TRANSMITTAL LETTER AND ATTACHED COMMENTS REGARDING THE RECORD OF
DECISION FOR OPERABLE UNIT 9 (OU 9) SITE 16 NCBC DAVISVILLE RI
01/23/2014
DEPARTMENT OF THE NAVY

**Navy Response to
USEPA Region I Comments on
The Site 16 Draft Final Record of Decision Dated March 26, 2014
Former Naval Construction Battalion Center (NCBC) Davisville
Davisville, Rhode Island
(USEPA Region I Correspondence Dated May 1, 2014)**

**Navy Response to
RIDEM Comments on
The Site 16 Draft Final Record of Decision Dated March 26, 2014
Former Naval Construction Battalion Center (NCBC) Davisville
Davisville, Rhode Island
(RIDEM Correspondence Dated April 22, 2014)**

Re: *"Navy Response to EPA Region I Comments on the Revised Draft Feasibility Study for Site 16"*, dated August 2011 at the Former Davisville Naval Construction Battalion Center (NCBC), Rhode Island

Figure 1. Histogram of NCBC soil arsenic background values with (n = 18) and without (n = 12) 6 samples containing PCBs and other contamination.

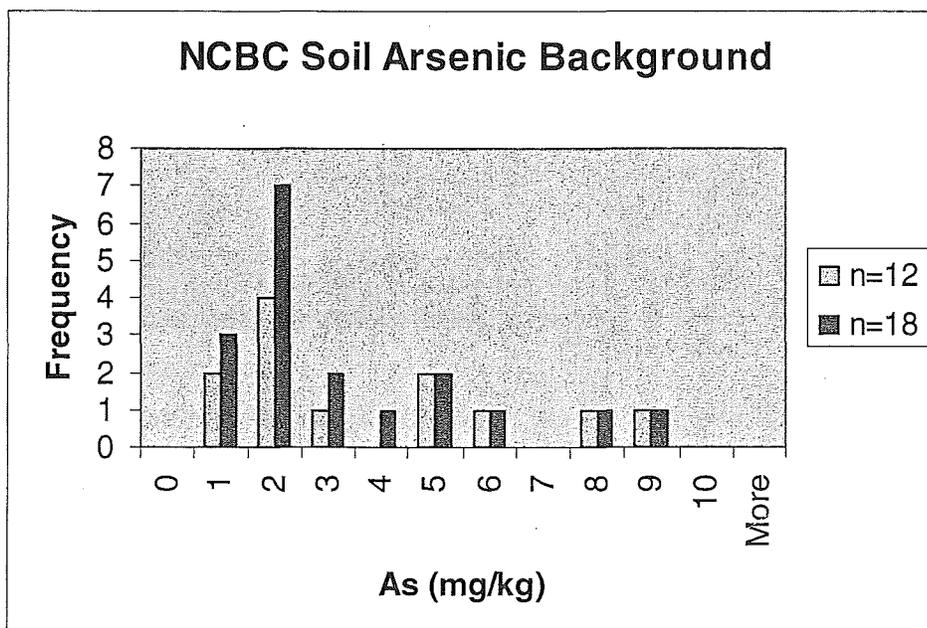
For comparison, the Mabbett Team also examined the $n = 18$ data set in order to maximize the number of detected arsenic values for ProUCL analysis, regardless of the presence of other contaminants. The range of arsenic values in the contaminated samples (0.95 mg/kg to 3.4 mg/kg) is within the range of values (0.59 mg/kg to 8.1 mg/kg) in the uncontaminated samples, as shown on Figure 1 (below). This observation suggests that the presence of PCBs, pesticides, and other contaminants has not biased the distribution of arsenic concentrations in the compromised samples.

The 95% UPL calculated for the n = 18 data set is 6.9 mg/kg. As the number of samples used to calculate upper-bound estimates increases, the UPLs decrease. This observation is consistent with the definition of UPL given above. As the UPL decreases, the number of site samples that will be identified as potentially contaminated, requiring further scrutiny, may increase.
